Mobile Intel® Celeron® Processor on .13 Micron Process in Micro-FCPGA Package

Specification Update

Document Number: 251309-023

Figure 12. System Bus Reset and Configuration Timings

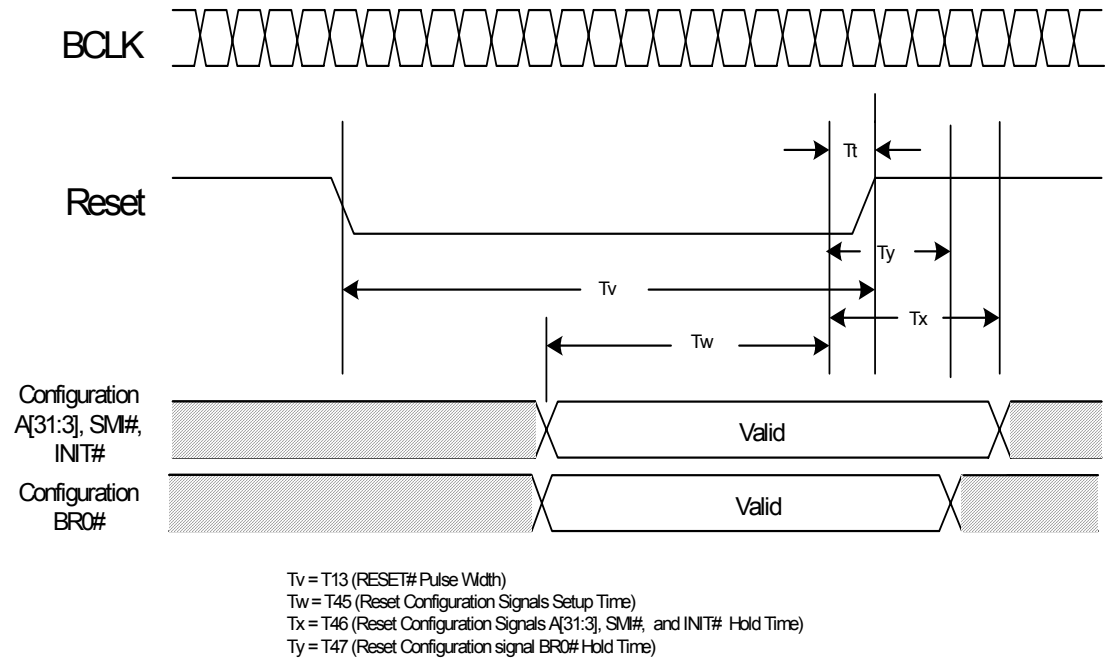
V2. BR0# Maximum Hold Time Specification Change

The BR0# maximum hold time has changed to 2 BCLKs. This change will be shown in the “System Bus AC Specifications (Reset Conditions)” table and “System Bus Reset and Configuration Timings” figure of the *Mobile Intel® Celeron® Processor on .13 Micron Process in Micro-FCPGA Package Datasheet*. This change will be incorporated in the next revision of the datasheet.

The following figure will be modified to reflect this change:

T# Parameter	Min	Max	Unit	Figure	Notes
T45: Reset Configuration Signals (A[31:3]#, BR0# INIT#, SMI#) Setup Time	4		BCLKs	13	1
T46: Reset Configuration Signals (A[31:3]#, INIT#, SMI#) Hold Time	2	20	BCLKs	13	2
T47: Reset Configuration Signal BR0# Hold Time	2	2	BCLKs	13	2
